1. INTRODUCTION

This note provides a response to the comments on the Flints Park SHA EOI Transport Assessment (TA) Report and TA Addendum as provided by Novo Group in their letter dated 3/4/19. No response is provided within this note to the Glenpanel SHA comments.

Image 1 – Hobsonville Point – Precedent for Laneways serving 27 or more dwellings

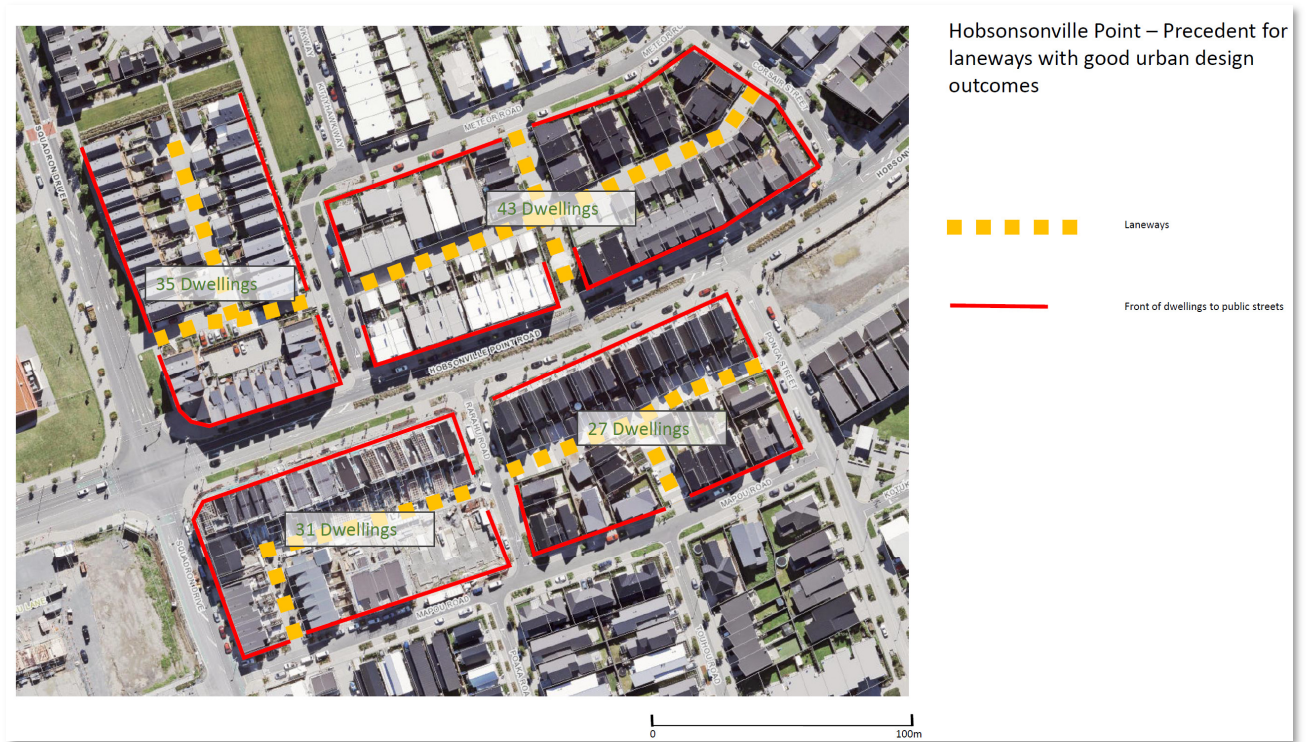
- There is an inconsistency between the QLDC District Plan and the QLDC LDCP where they refer to 12 and 20 dwellings accessed off jointly owned access ways.

- These standards appear to be inconsistent with achieving good urban design outcomes, where the use of rear lanes to provide access to medium density housing often have more than 12 or 20 dwellings accessed off a rear lane. The standards as written are typical of standards that are designed to avoid substandard suburban outcomes where large numbers of dwellings are accessed off a single JOAL with no individual access to public streets or parks etc. The proposed layouts at Flint's Park are such that the JOALs are used for private vehicle access, with all dwellings having direct pedestrian access and orientation to the public streets.

- There are many precedents of where laneways are used by more than 20 dwellings, while still delivering on excellent urban design outcomes (Refer to Image 1 below at Hobsonville Point). In the case of Flint's Park, the laneways have multiple entrance and exits points, are shorter than the Hobsonville Point example and the maximum number of dwellings served is only 27.

- Overall it is concluded that the design of the block structure with rear lanes proposed will result in excellent urban design outcomes and is an important element when increasing density. The alternative with endless vehicle crossings and garages directly off the public streets will result in poor amenity and pedestrian outcomes.
